Technical change

Design change for Weidmüller battery connectors

3. Change details

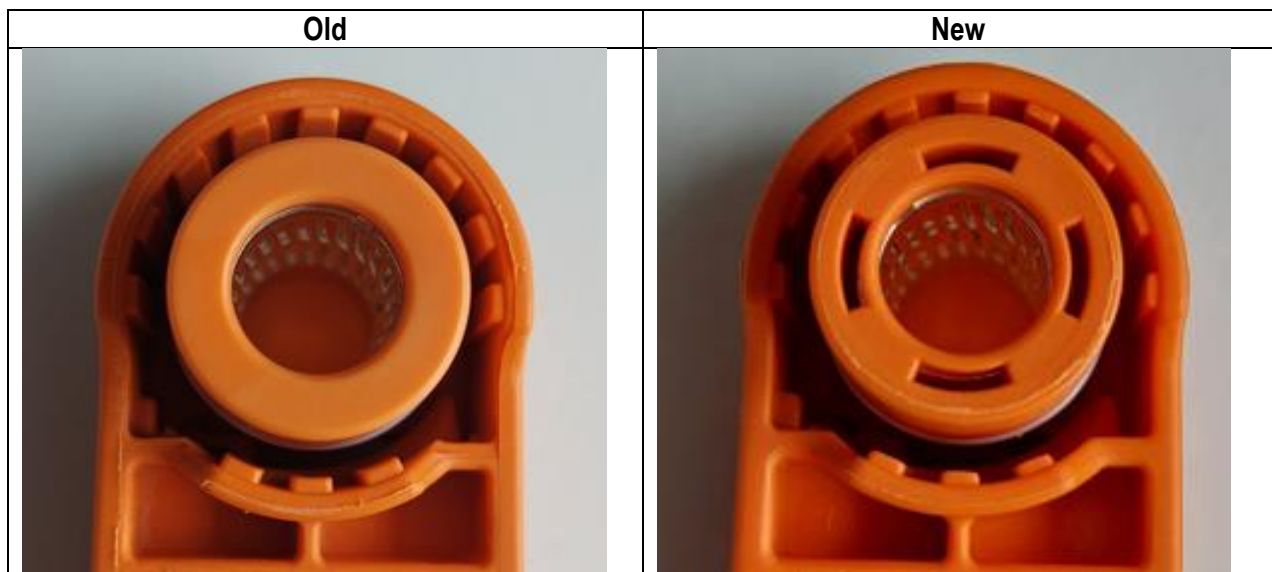
Four small cuts are made in the plastic housing of the plug around the contact element. This won't have any influence to the function or technical specs.
